N6705A-04A**S E R V I C E N O T E**Supersedes:
N6705A-04**N6705A DC Power Analyzer**

Firmware update will address an issue where N6705A mainframes with firmware A.02.03 results in self-test errors for N6751A, N6752A, N6761A and N6762A modules.**To Be Performed By: Agilent-Qualified Personnel or Customer****Parts Required:**

Figure 1. N6705A mainframe (A.02.03) with N6751A modules in Channel 1 and Channel 2

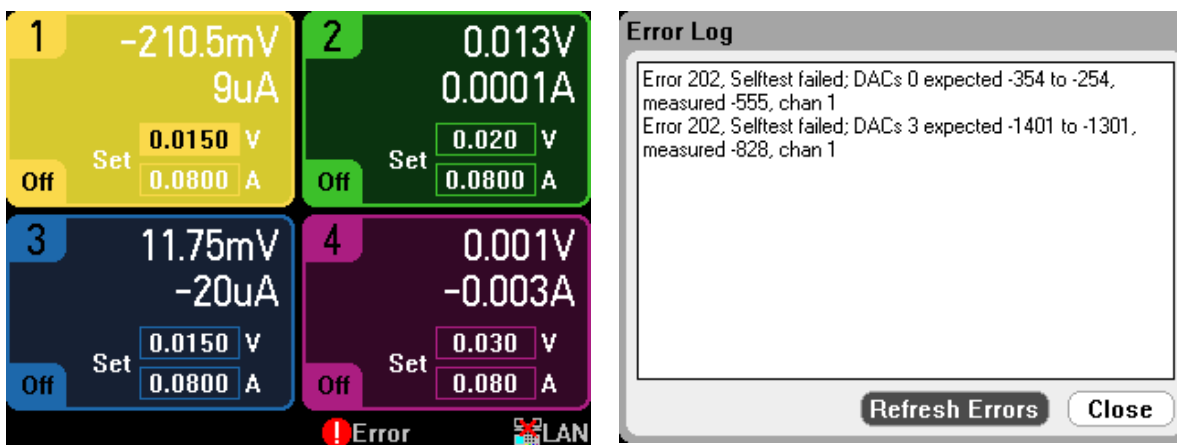
All N6705A mainframes with firmware version A.02.03 have the potential to incorrectly configure N6751A, N6752A, N6761A and N6762A modules. This will result in an Error 202 Selftest failed and the output voltage being programmed to unexpected levels.

First, check the firmware revision of the N6705A mainframe. To do this using one of the IO interfaces, send the “*IDN?” query. Over the front panel use the following sequences of keystrokes:

If the firmware version is A.02.03 or older then the firmware must be upgraded. All files, programs, and instructions required to upgrade the firmware are located at the following website:
